Black Rock Geothermal Project (23-AFC-03) Preliminary Staff Assessment Comments

Prepared by
Black Rock Geothermal LLC

September 4, 2024

Figure 5.2-1R
Land Cover and Vegetation Types
Black Rock Geothermal Project
Imperial County, California

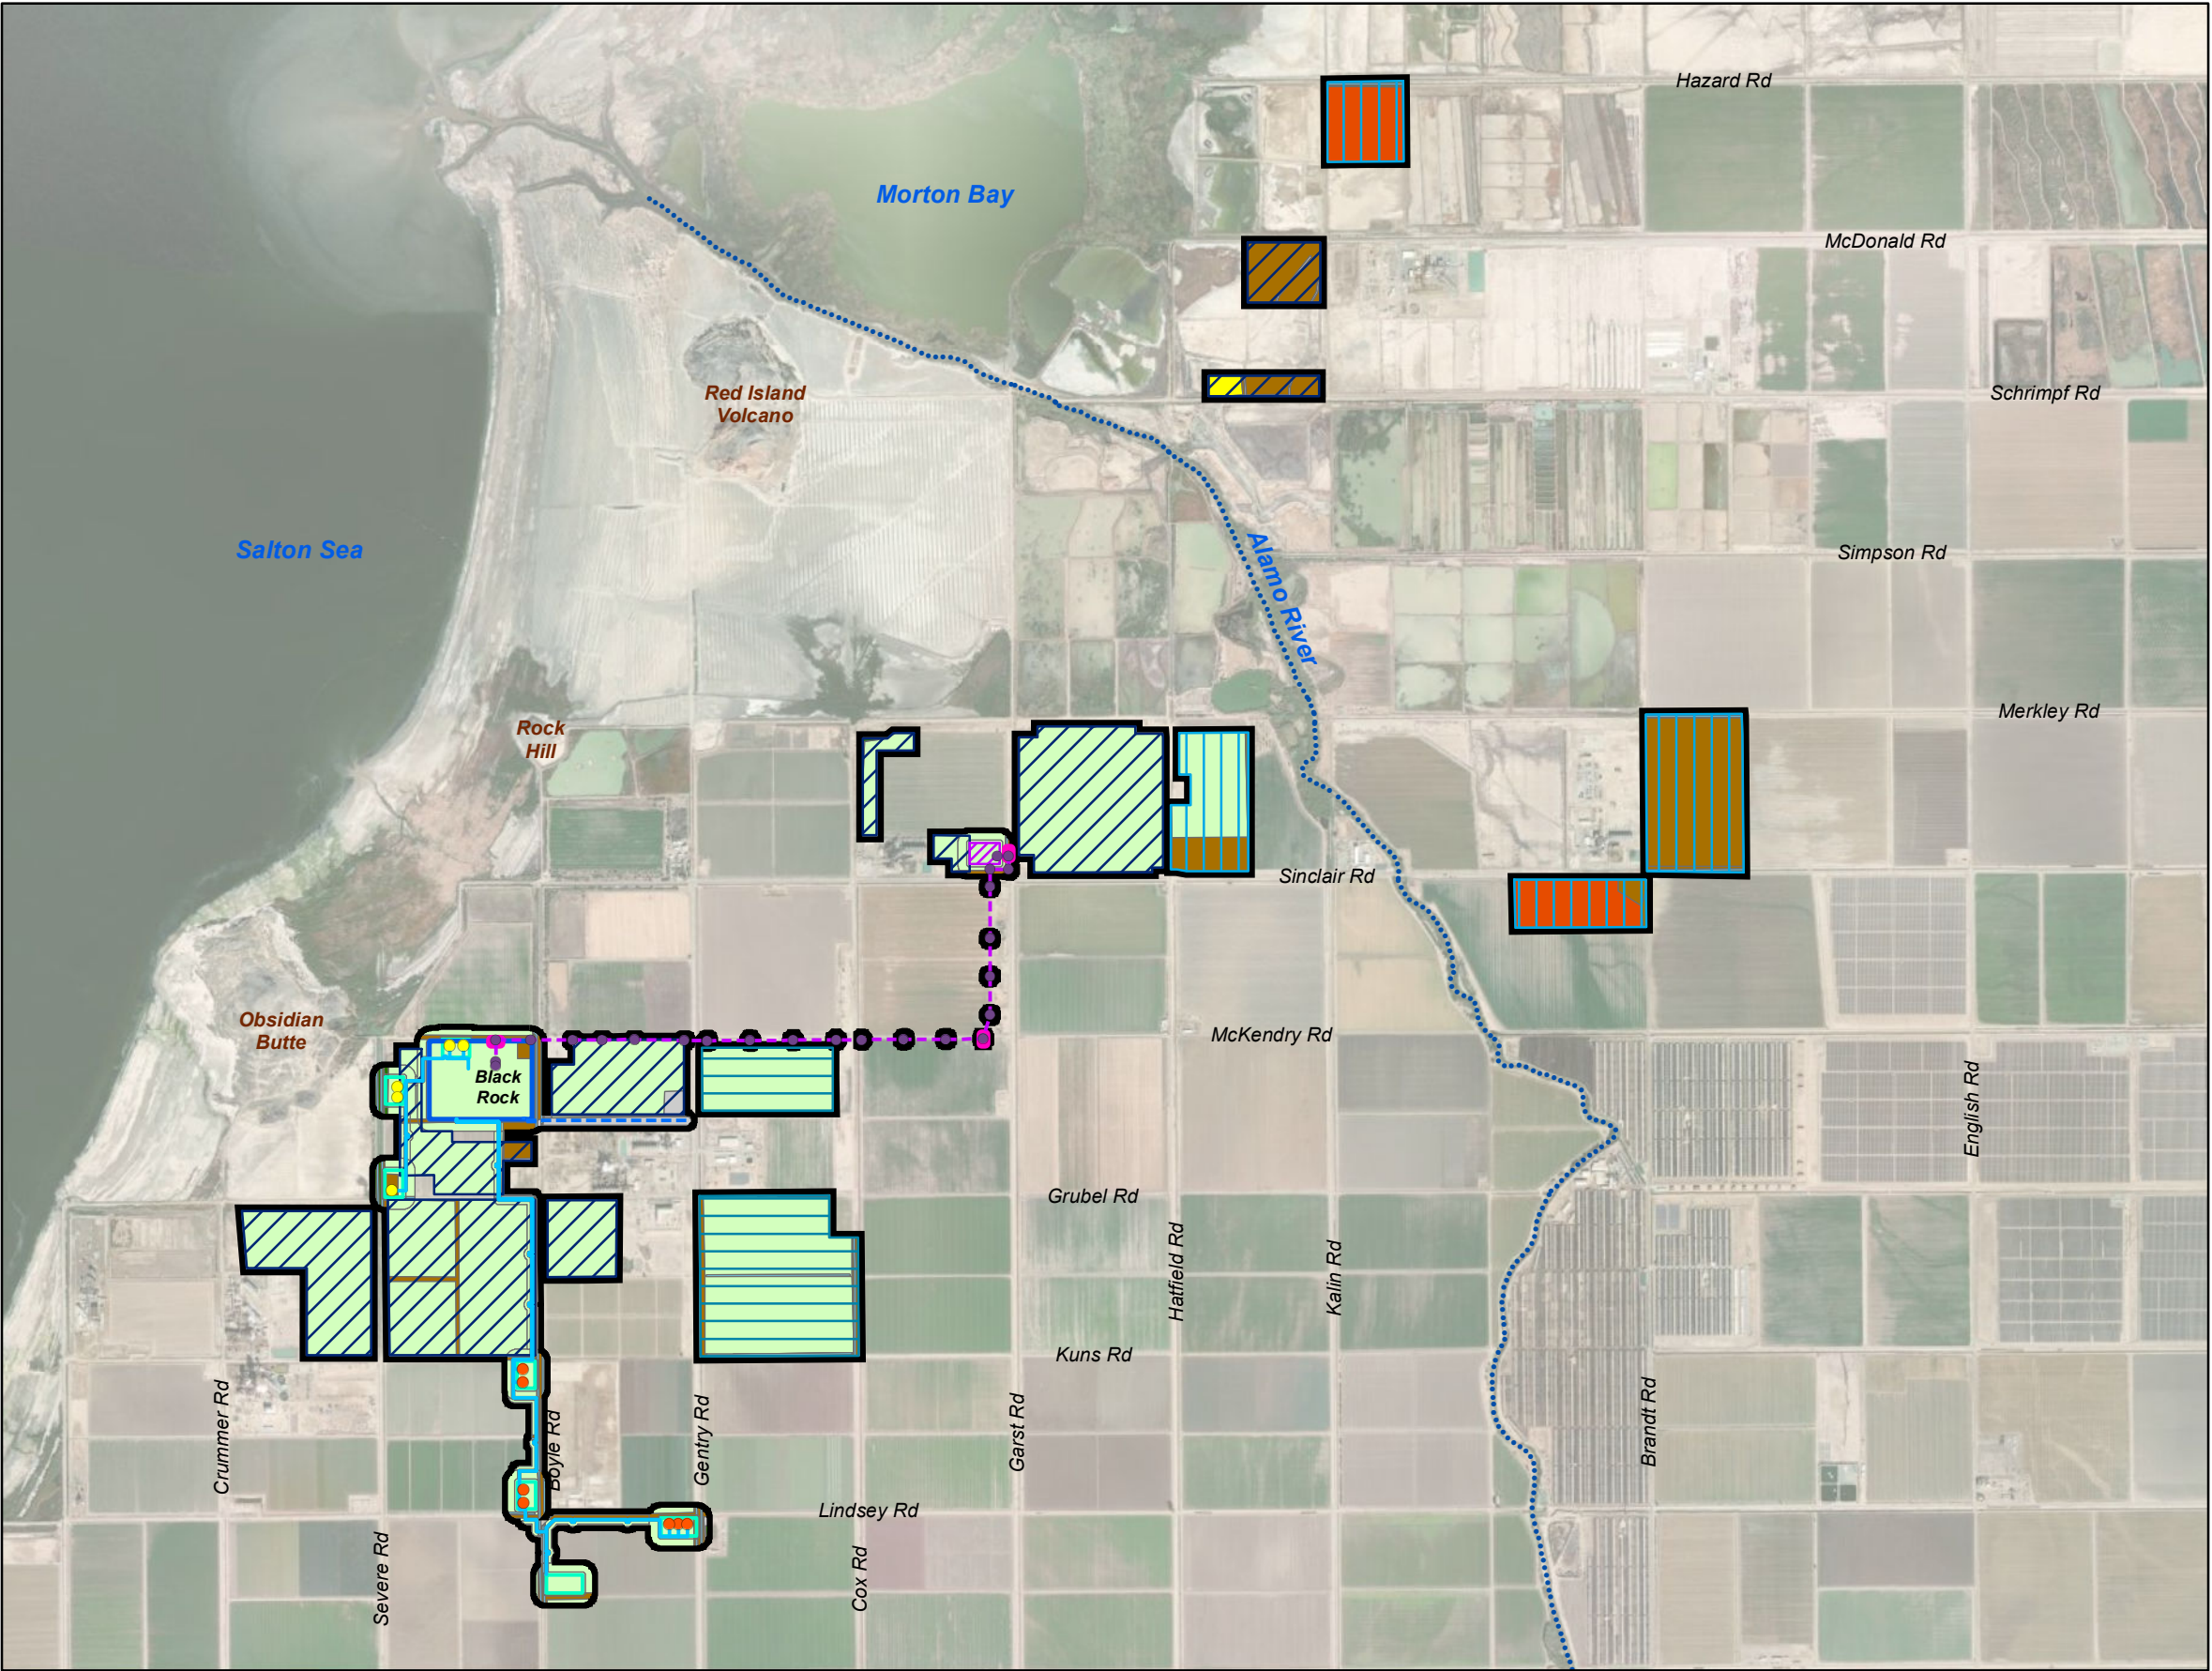
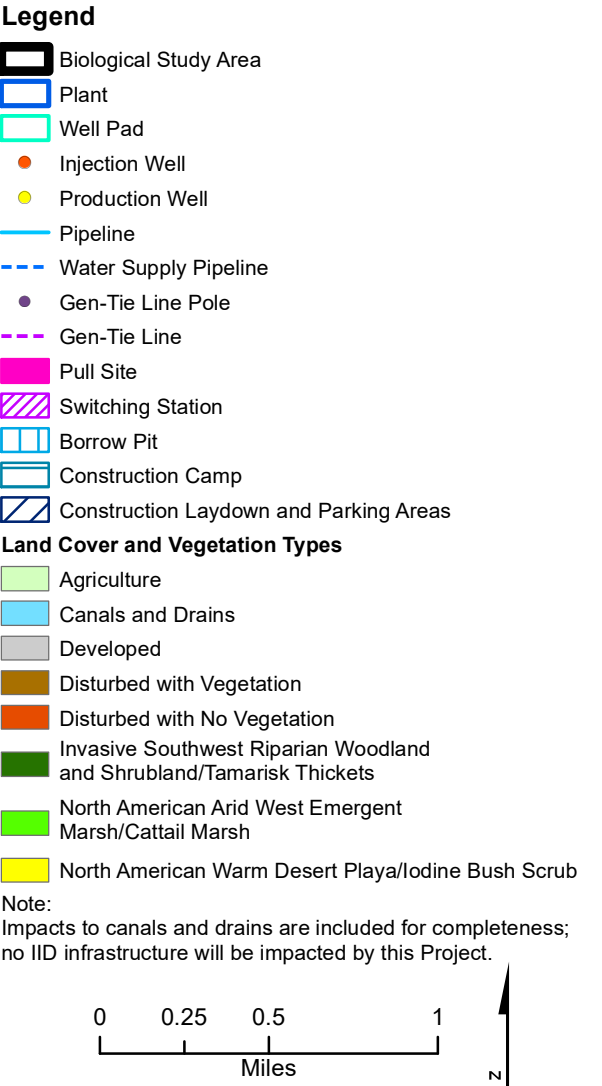
Pages 5.2-38 , Table 5.2-2 – The project does not contain suitable cottonwood or dense tamarisk nesting habitat for southwestern willow flycatcher (see updated **Figure 5.2-1R** and revised **Table 5.2-5** for current vegetation and land cover types within the project area). Southwestern willow flycatcher were not listed on the IPaC generated March 28, 2023. Although the adjacent SBSSNWR has riparian and wetland habitats, Southwestern willow flycatcher is not included on SBSSNWR Wildlife List (USFWS 2018). This species is not expected to nest or forage in the project area. This species could be present rarely during migration.

Although Table 5.2-5 shows that 0.40 acres of marsh are within the temporary disturbance footprint, these areas will not be impacted (**Figure 5.2-1R**). The first marsh habitat mapped is a thin strip on the east side of the northernmost borrow pit that will not be directly impacted. The second marsh habitat mapped is in the 150-foot buffer of the southeastern most injection well pad which is across Gentry Road and will not be directly impacted.
